VILLAGE OF DOWNERS GROVE
Report for the Village Council Meeting
6/21/2016

SUBJECT:	SUBMITTED BY:
Preliminary Plat of Subdivision - 5527 - 5531 Fairmount Avenue	Stan Popovich, AICP Director of Community Development

PRELIMINARY PLAT OF SUBDIVISION

SUBJECT:	TYPE:	SUBMITTED BY:
16-PLC-0020 5527-5531 Fairmount Avenue	Preliminary Plat of Subdivision	Scott Williams Planner

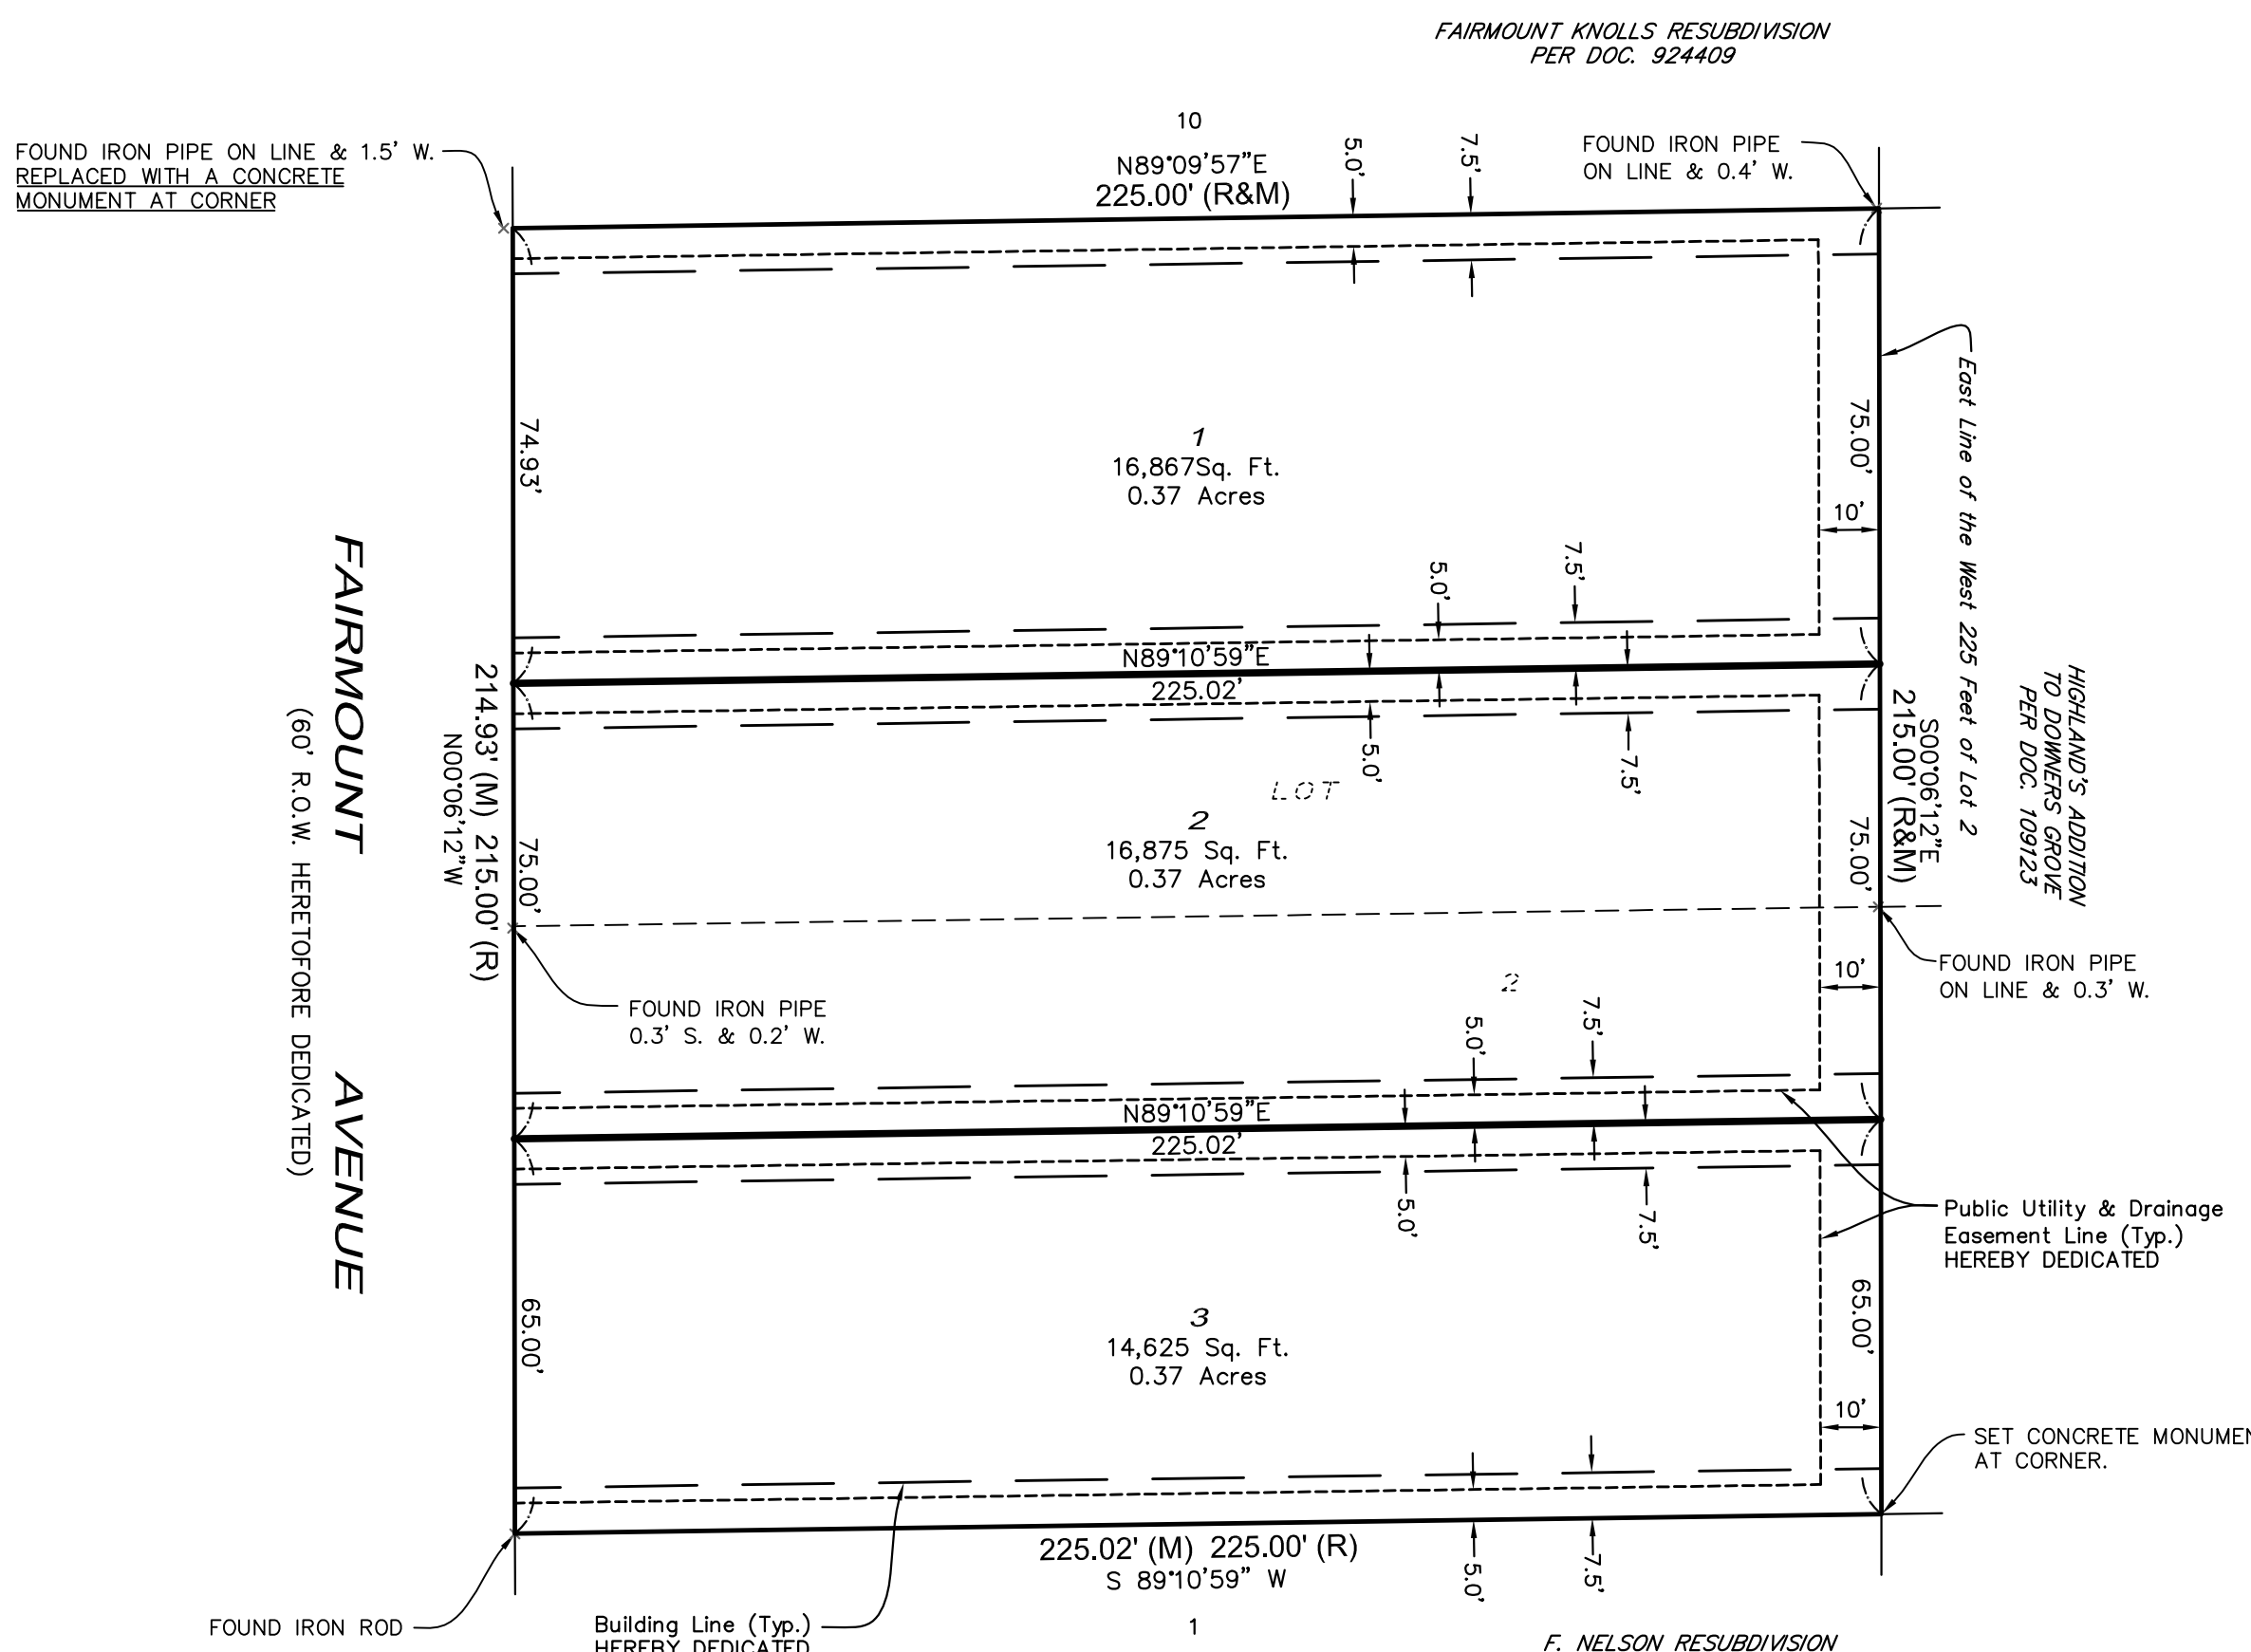
The three residential lots will not meet the minimum lot width dimension requirements outlined in Section 20.301 of the Village's Subdivision Ordinance. The proposed lot dimensions are specified in the table below:

Three lot width exceptions are requested to reduce the required lot widths from 75-feet to approximately 71.65 feet for Lots 1 through 3. The reduction of the required lot width allows the construction of three new single family homes, but there are no required public improvements or unique circumstances that would cause the reduction in the lot width.

The petitioner is requesting an exception for three lots to permit 71.64 & 71.65 lot widths where a minimum of 75-feet is required. The petitioner's difficulty is that the subject properties are not wide enough to establish three 75-foot wide lots per the Subdivision and Zoning Ordinances. The standards of approval for the three requested lot width exceptions are outlined below.

The redevelopment of the subject property could have an impact on the surrounding properties. By permitting the subdivision to create new lot widths under 75, it could lead to the subdivision of other lots within the neighborhood. The increase of buildable lots in the neighborhood could increase the density of the neighborhood and change the character of the neighborhood. This standard is not met.

The area is primarily residential and the proposed lot widths are not consistent with existing lot widths in the area. Specifically, the immediate vicinity north of the park in which the subject property is located has an existing average lot width of 89' with only 25% of the lots being under the 75' width.

The petitioner is requesting the lot width exceptions for the three lots in order to create three buildable lots. The reasoning for requesting the exceptions is not supported by the need to provide public improvements or limiting physical characteristics of the land. Without unique characteristics, the approval of the request could lead to arbitrary approvals of other exceptions that increase density in the neighborhood or throughout the Village. This standard is not met.

The requested exceptions are not in conformance with the Comprehensive Plan nor are they in conformance with the spirit of the Subdivision Ordinance. The Comprehensive Plan looks to ensure compatibility with the adjacent neighborhood and the proposed exceptions do not accomplish this. The proposed lot widths are not consistent with the majority of the surrounding lot widths. The requested exceptions are not necessary to comply with other provisions of the subdivision ordinance, whether that is public utilities or easement provisions. This standard is not met.

The proposal is not consistent with the character of the locality. The majority of the lots on Fairmount Avenue are greater than 75 feet in width. If approved, the exception has the potential to change the essential character of the neighborhood by permitting other exceptions in the neighborhood where there are no unique site characteristics. If additional subdivisions occur, the density of the immediate area could increase. This standard is not met.

1. The Final Plat of Subdivision shall substantially conform to the Preliminary Plat of Subdivision prepared by Professional Land Surveying, Inc. dated 10-21-2015, last revised on June 16, 2016, depicting Lot 1 and Lot 2, each having a lot width of seventy-five feet (75'), and Lot 3 as having a lot width of sixty-five feet (65') and thereby granting the following exception:

- a. An exception from Chapter 20, *Subdivision Ordinance*, Section 20.301; *Lot Widths*, to reduce the required right of way width of seventy-five feet (75') feet to sixty-five feet (65') feet for Lot 3.

2. Park and school donations must be paid prior to approval of a Final Plat of Subdivision.
3. Each of the three lots in Park View Resubdivision shall have a side yard setback of no less than 7.5 feet. The side yard setback shall be indicated on the Plat of Subdivision as building lines.

4. The petitioner shall prepare and file engineering drawings in accordance with Section 20.504.c of the Municipal Code in conjunction with the final plat approval request. The drawings must be in conformance with Village ordinances as confirmed by the Village Engineer.

5. Upon completion of engineering drawings establishing the 100-year floodplain location, the applicant shall place upon the final plat a stormwater easement over the 100-year floodplain in accordance with Village easement standards.
